**WARRANTY
BULLETIN**

Wb00-33

DATE : NOVEMBER 2000	SECTION :	12 - Brakes
EXPIRATION: NOVEMBER 2001		
SUBJECT : BRAKE PEDAL ROD LINKAGE

FIGURE 1: BRAKE PEDAL ROD LINKAGE

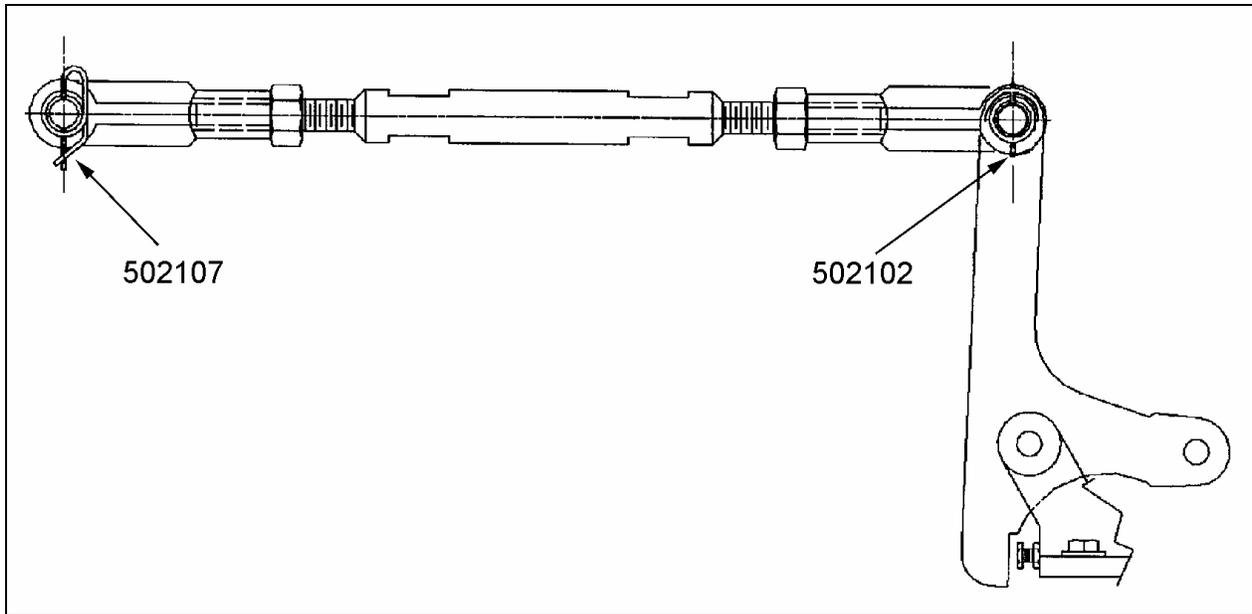
A locking pin must be installed in place of the hitch pins currently installed on the above vehicles.

1. Access the rod linkage through the front bumper compartment. The rod is located on the driver's side of the vehicle, close to the ceiling;
2. Remove the hitch pins as illustrated in figure 1 and replace with a cotter pin (#502102) on the end closest to the brake valve and a locking pin (#502107) on the other end of the rod (Refer to figure 1).

Part No.	Description	Qty
502107	Locking pin	1
502102	Cotter pin	1
